TOWN AND COUNTRY PLANNING ACT 1990 (AS AMENDED)
2017/5627/P – 61 NETHERHALL GARDENS

Further to our previous discussions and correspondence dated 29th January we hereby submit the following additional information in relation to the above application:

l. be set back from neighbouring property boundaries where it extends beyond the footprint of the host building; and

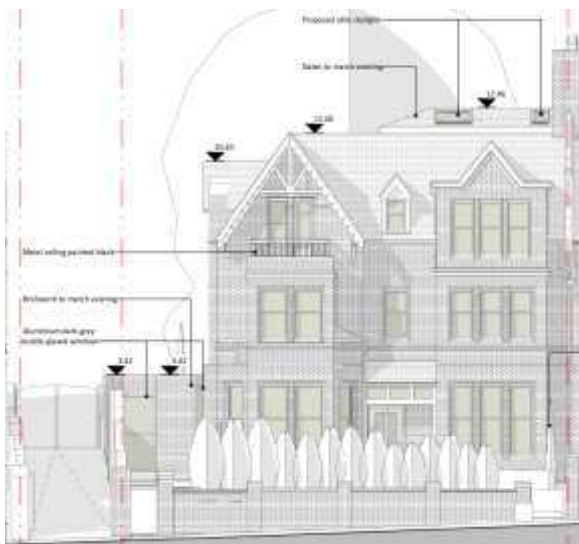
The rear lightwell has been adjusted and is now set in from the boundary with number 63 Netherhall Gardens. The proposal therefore complies with this criterion.

Side Extension - Original Scheme

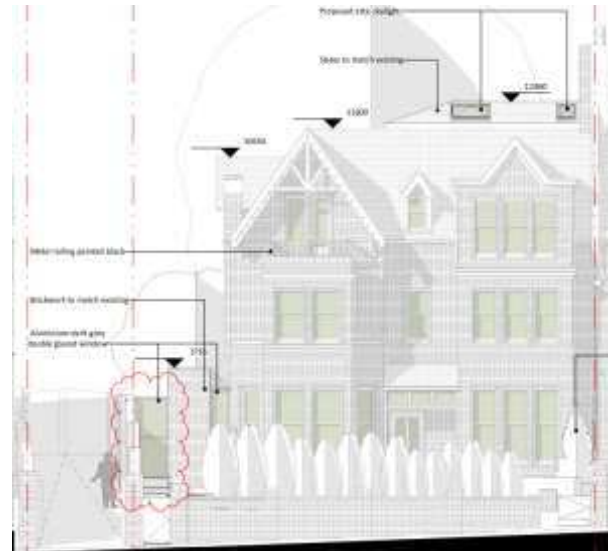
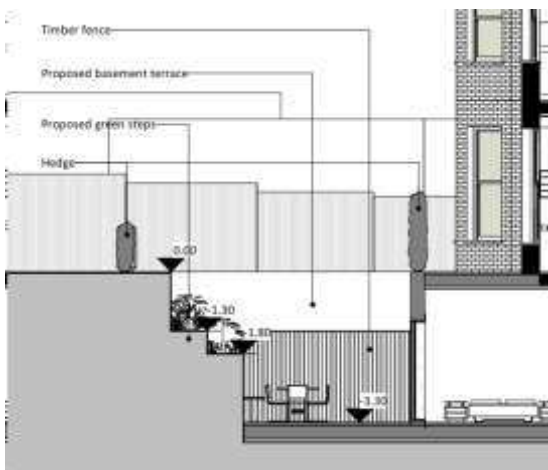
In direct response to comments made in relation to the overall level of development proposed, the shape and form of the proposed replacement side extension has been amended and the boundary wall lowered in order to keep its massing very close to the existing arrangement.

Lightwell - Original Scheme

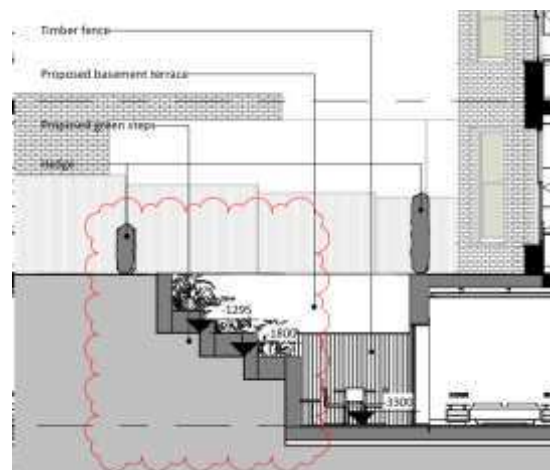
Furthermore, the proposed rear lightwell terrace has been reduced in depth, set in from the boundary and is now stepped to reduce its impact upon the garden area.
